# UNITED STATES PATENT AND TRADEMARK OFFICE

APPLICATION NO.	FILING DATE	FIRST NAMED INVENTOR	ATTORNEY DOCKET NO.	CONFIRMATION NO.
09/841,570	04/24/2001	Gary Boccadutre	1647001	5425

<b>Office Action Summary</b>	<b>Application No.</b> 09/841,570	<b>Applicant(s)</b> BOCCADUTRE ET AL.	
	<b>Examiner</b> Hadi Shakeri	<b>Art Unit</b> 3723

## **DETAILED ACTION**

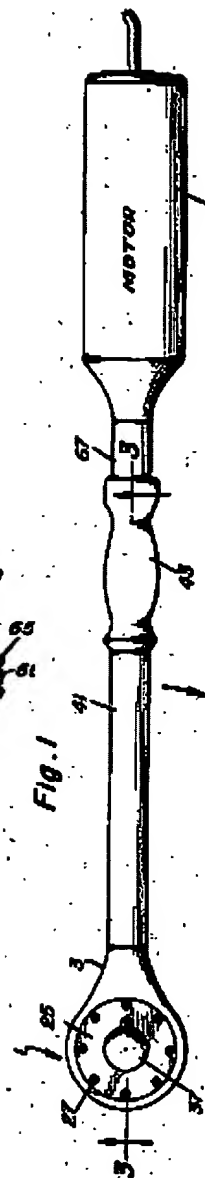
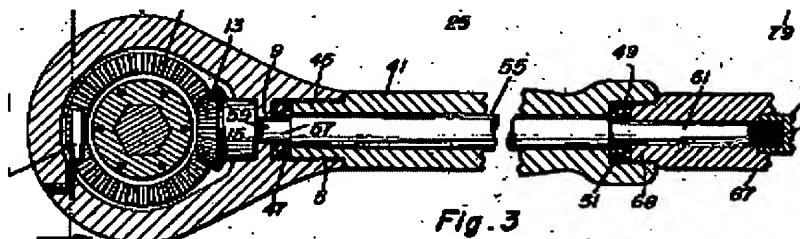
9. Claims 1, 3, 7, 9 and 11 are rejected under 35 U.S.C. 102(b) as being anticipated by Lampke, US Patent No. 2,808,749.

Lampke discloses all the limitations of claims 1 and 11, i.e., power wrench comprising a handle containing a motor; a ratchet extension, (41); a ratchet extension shaft (55); and a ratchet head (1).

Regarding claim 3,  
wherein the extension and  
shaft are removable.

Regarding claims 7

and 9, wherein the heads and the handle are removable, and the extension and the shaft are “fixedly” attached to the handle and head respectively (fixedly is considered as a fixed attachment and not “unitary”).

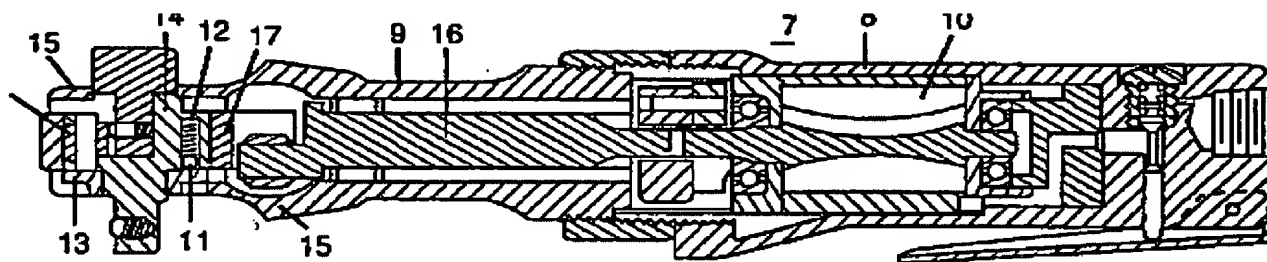
10. Claims 1, 3, 7, 9 and 11 (as best understood) are rejected under 35 U.S.C. 102(b) as being anticipated by Applicant's Admitted Prior Art (AAPA).

As admitted by Applicant, lines 135 and 136, a power ratchet wrench as shown in Fig. 3 is old, thus meeting the claims limitations as explained above.

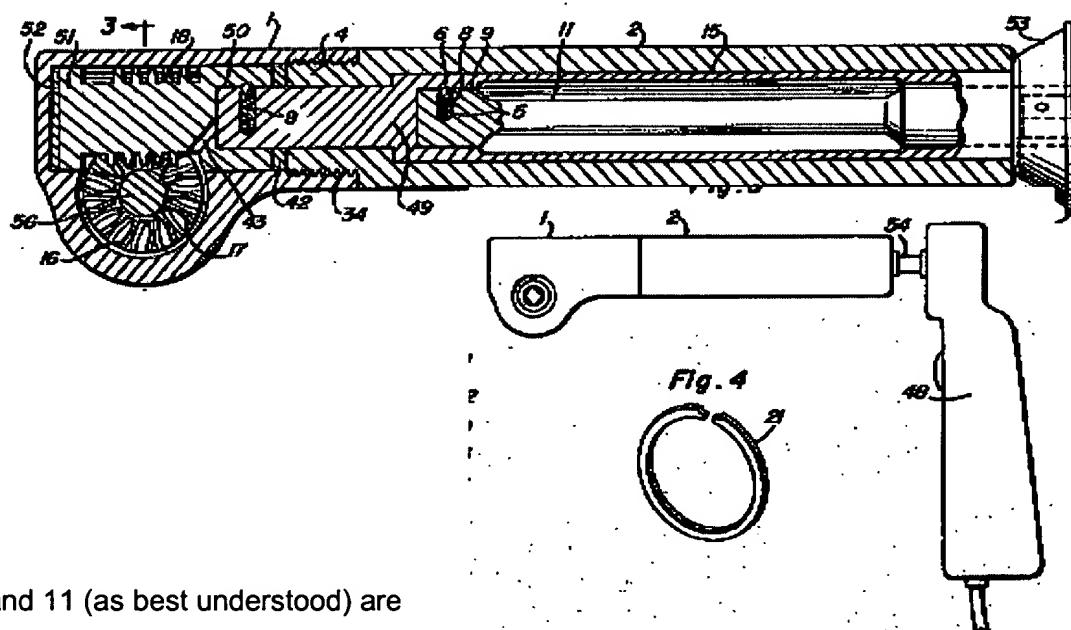
12. Claim 11 is rejected under 35 U.S.C. 102(b) as being clearly anticipated Hendrickson, US Patent No. 3,430,510.

Hendrickson  
clearly anticipates  
claim 1, e.g., Figs. 2  
and 5.

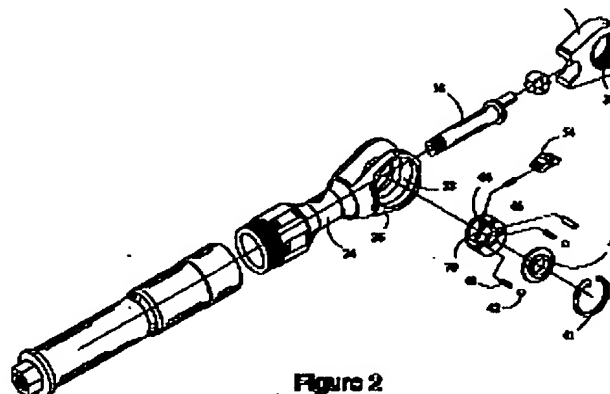
**13.** Claims 1, 3, 7, 9 and 11 (as best understood) are rejected under 35 U.S.C. 102(b) as being anticipated by Pijanowski, US Patent No. 5,967,002.

Pijanowski anticipates the above claims as best understood, i.e., a handle (23), a head removable from the handle, an extension and an extension shaft (23).
